ADDENDUM NO. 5

Re: Arch Job Number 24001, DCM #2025238, – Plans Dated: 3/31/25

New Lincoln Police Department

ADDENDUM ITEMS:

E11.0

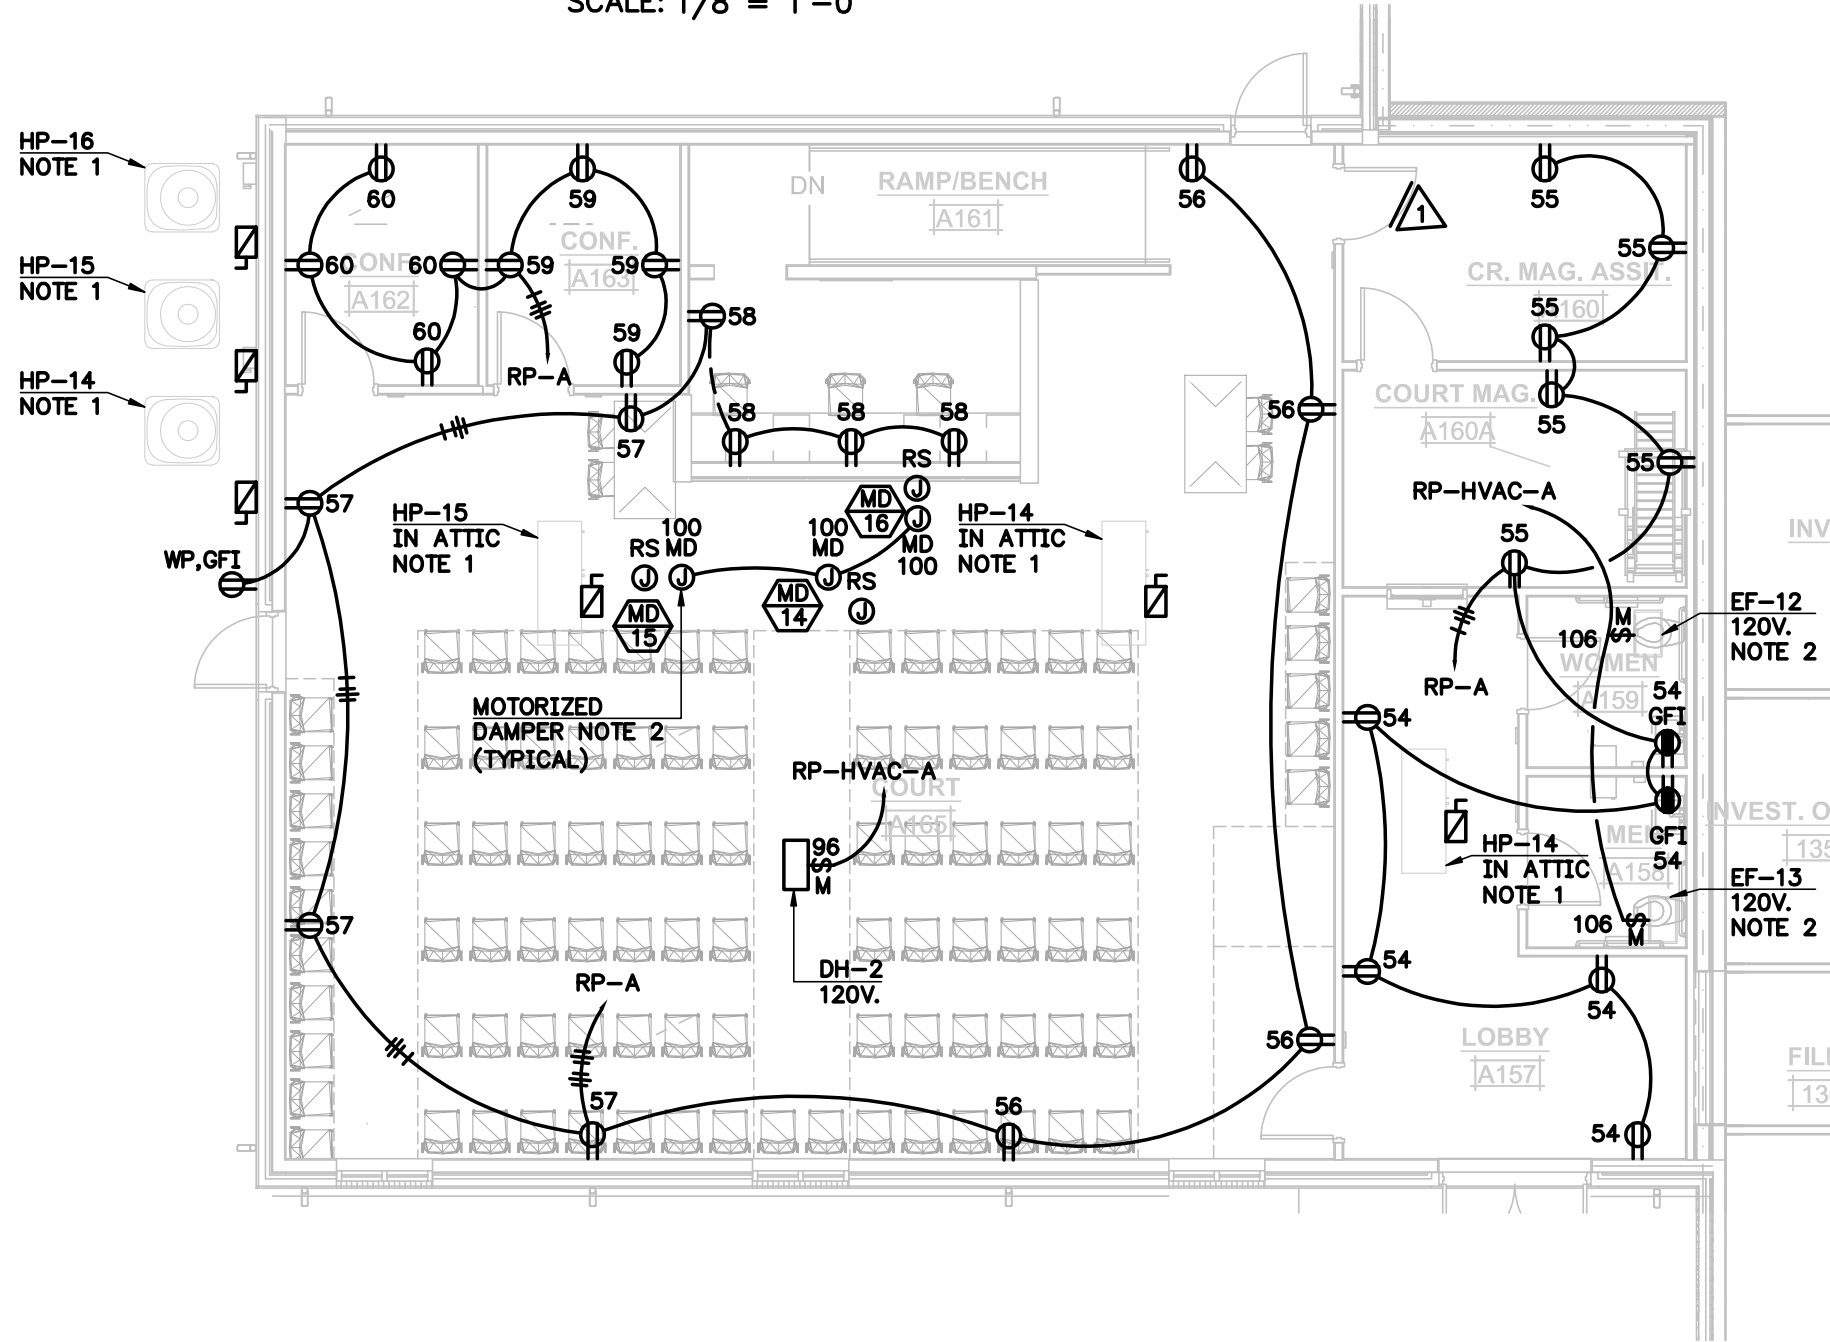
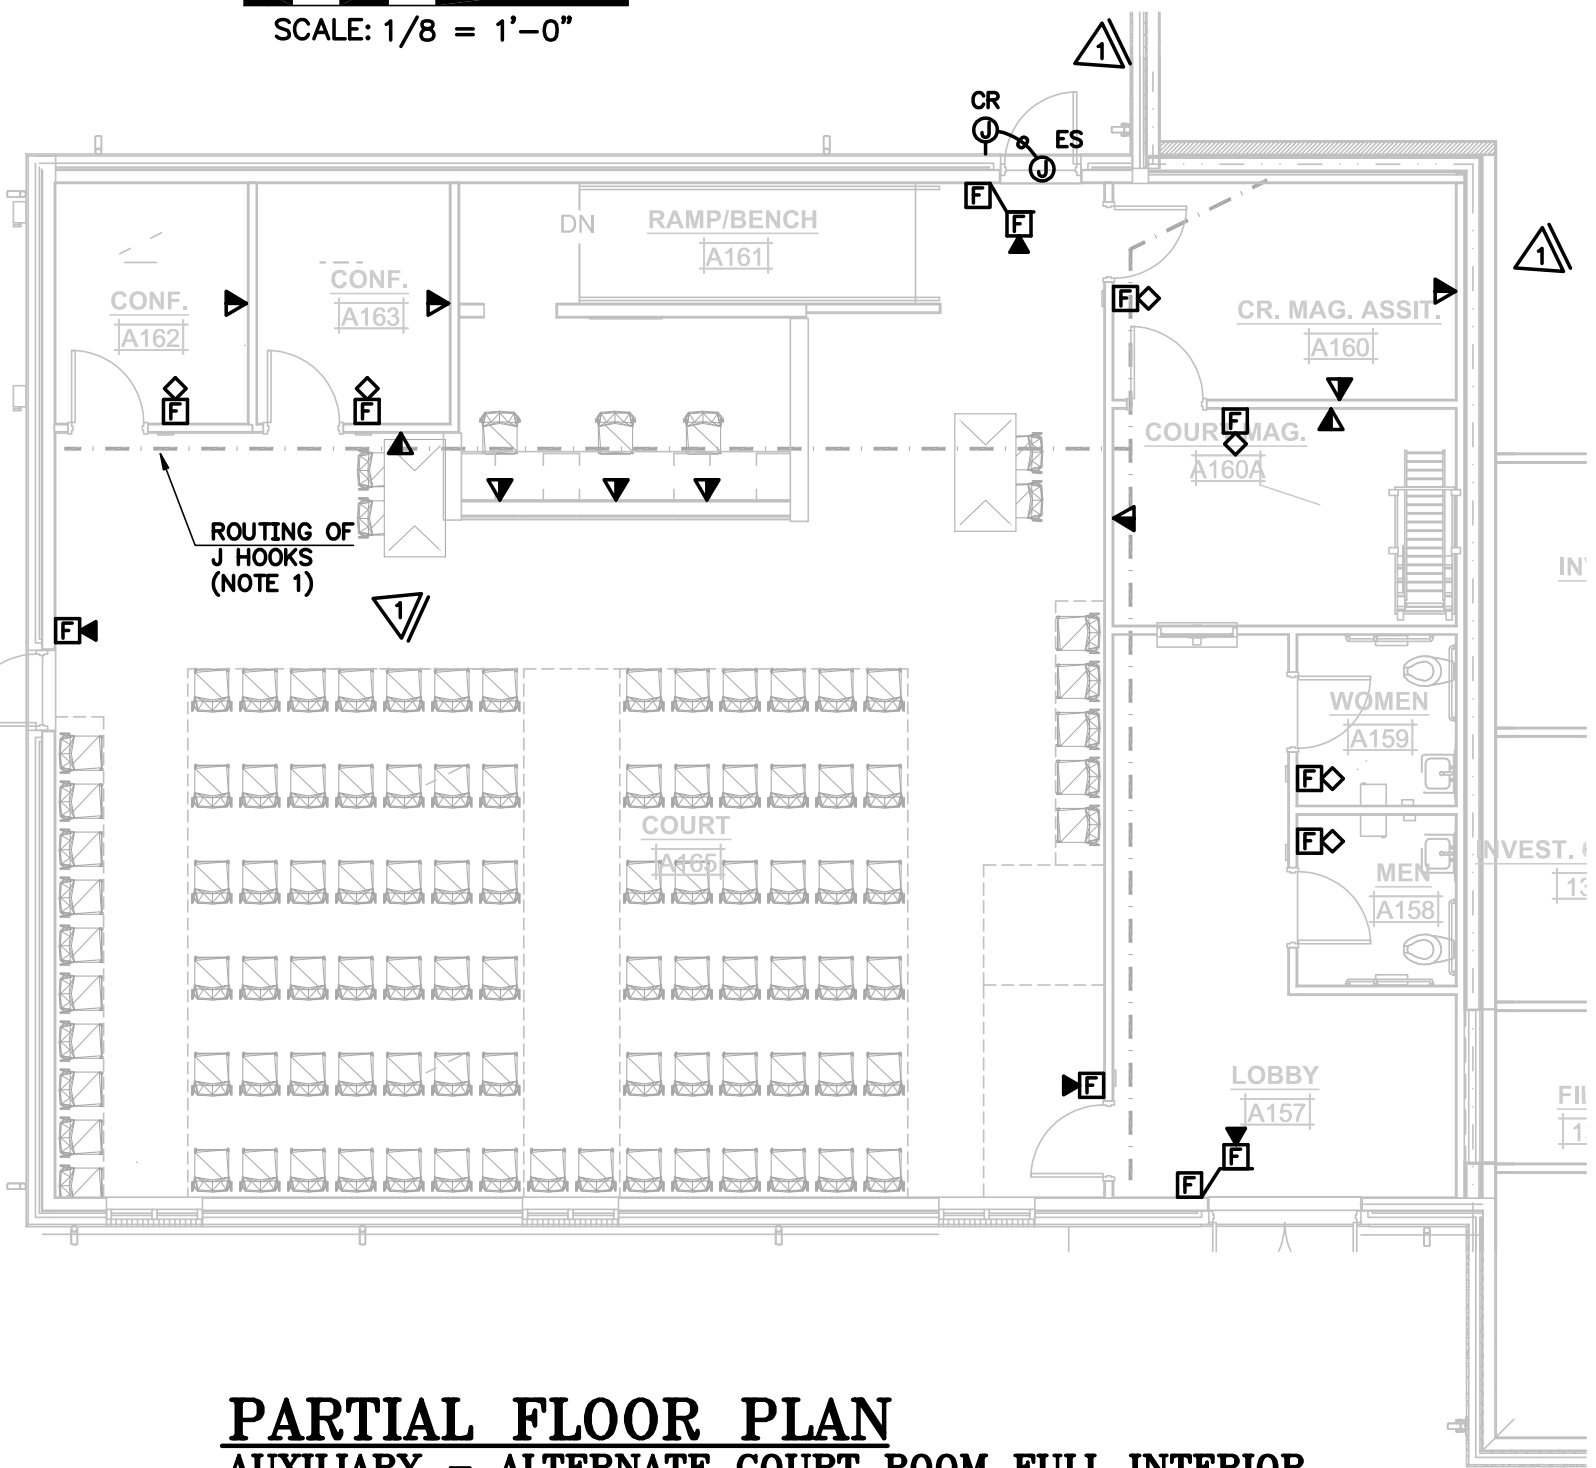
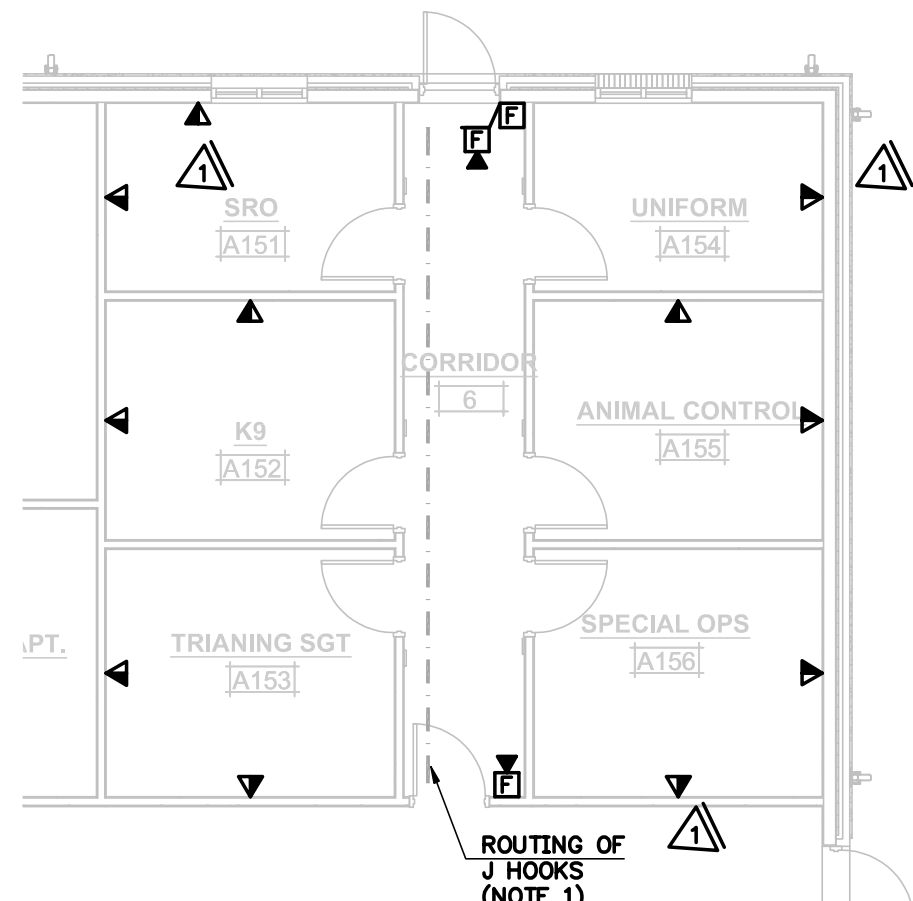
Comment No. 2: E11.0 - Make electrical and audio provisions for assisted listening system receivers that comply with 2010 ADA Standards (2010) 219.3 and Table 219.3. Coordinate with architect and verify requirements. Note that other than in courtrooms, assistive listening systems shall not be required where audio amplification is not provided. 2010 ADA Standards 219.2.

Response: Audio provisions have been added to revised drawings. (issued in Addendum)
3. OTHER Electrical Specifications not included with submittal. Provide sealed electrical specifications in accordance with Division of Construction Management Manual of Procedures 3(F)(4)(a). A review of the project cannot be completed without specifications.

Response: Audio provisions have been added to revised drawings.
